BELCO PETROLEUM CORPORATION OF PERU MEMORANDUM

A: Geology Manager February 8th, 1985
DF: Eng. Mario Chávez Asunto Geological Comments for proposed
Well LOG-6

A: Geology Manager	Fecha	February 11th, 19	985
<u> The state of the</u>			
DE: Chief Reservoir Engi	ineer Asunto	WELL LO6-6

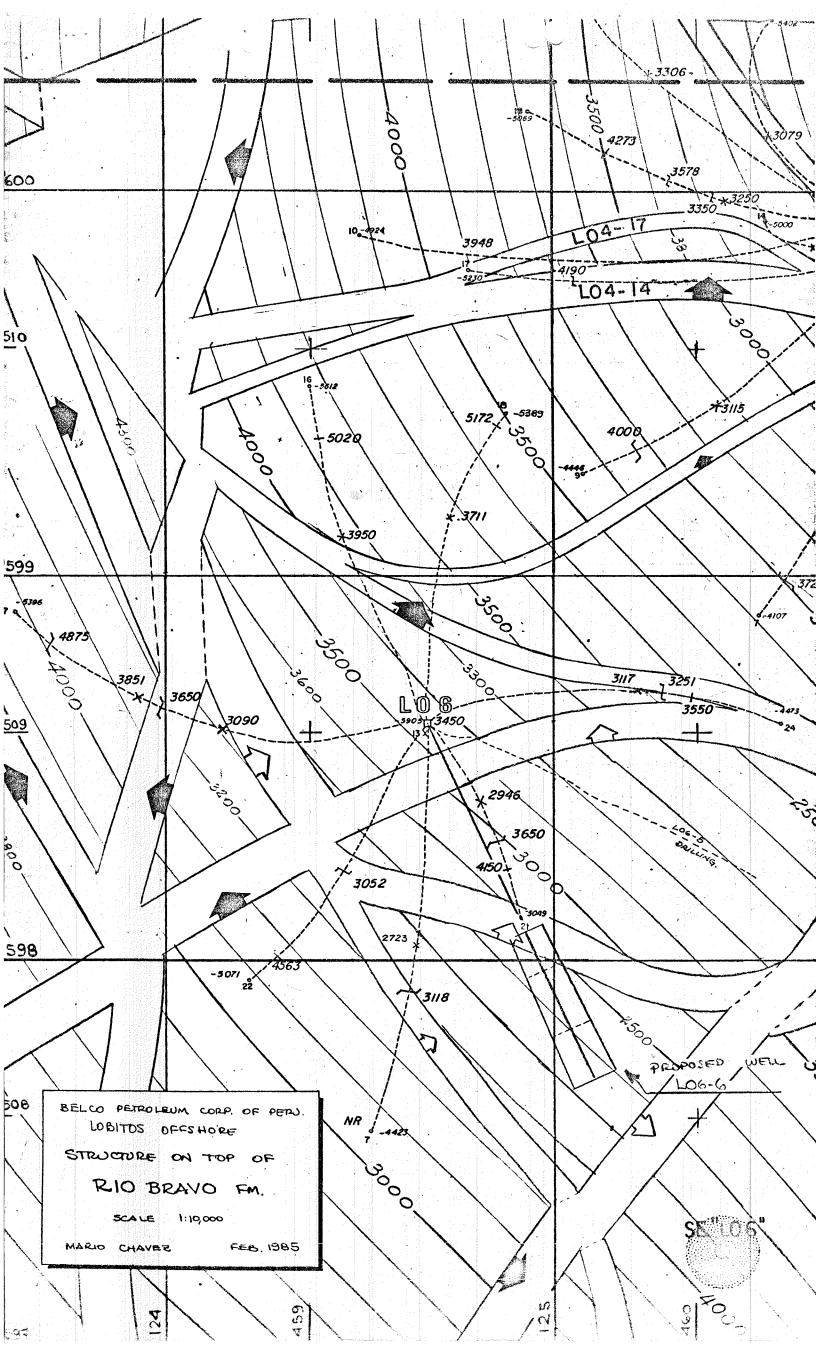
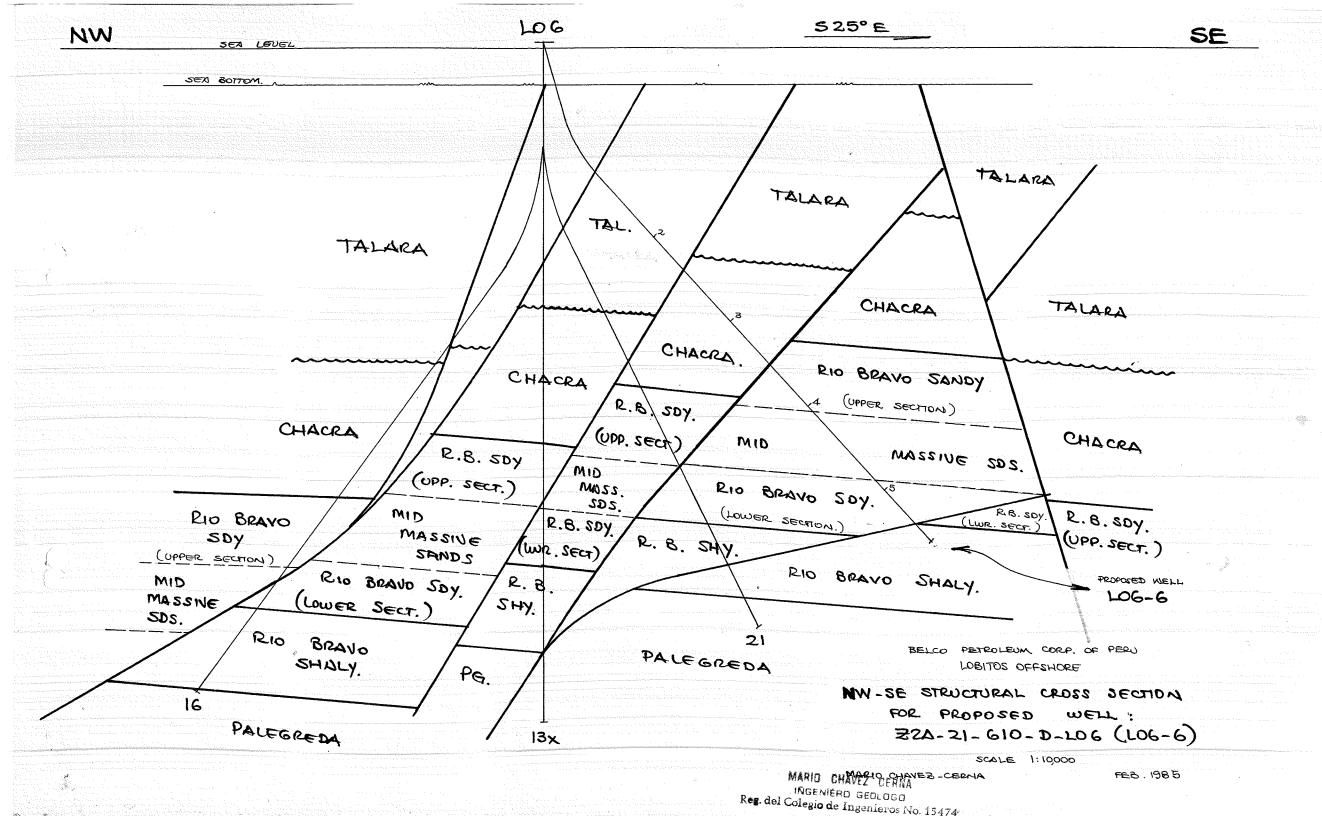
Reference well in order to drill the Mid Massive sands of the Río Bravo in an undrilled block of approx. 80 acres, located between wells L06-7, $L06-21\ \mbox{\&}\ L06-5$.

The expected production performance should be similar to well L06-22 which has very good correlation with well L06-7, however the production performance of this well does not agree with the quality of the reservoir, which could strongly indicate a failure during the completion,

The vertical angle is critical in order to keep sapacing with well LO6-21.

The logging program includes DLL-MSFL-GR and FDC-CNL-GR for complete evaluation of the Río Bravo sands.

The well of the reference is essentially a replacement of well LO6-21, which did not encounter the main sands due to faulting. The main sands presence in the area have been proven in wells LO6-22, 7 and partially in 5, which are located in the vicinity of the proposed well.

At the main sands level, the spacing is adequate with respect to the offsets. Logging program includes a complete set of logs not run in the offset wells. Target size is also in accordance with the guidelines.

It is important to build up the angle as specificed. Failure to do so may result in a well not adequately spaced with respect to L06-21.
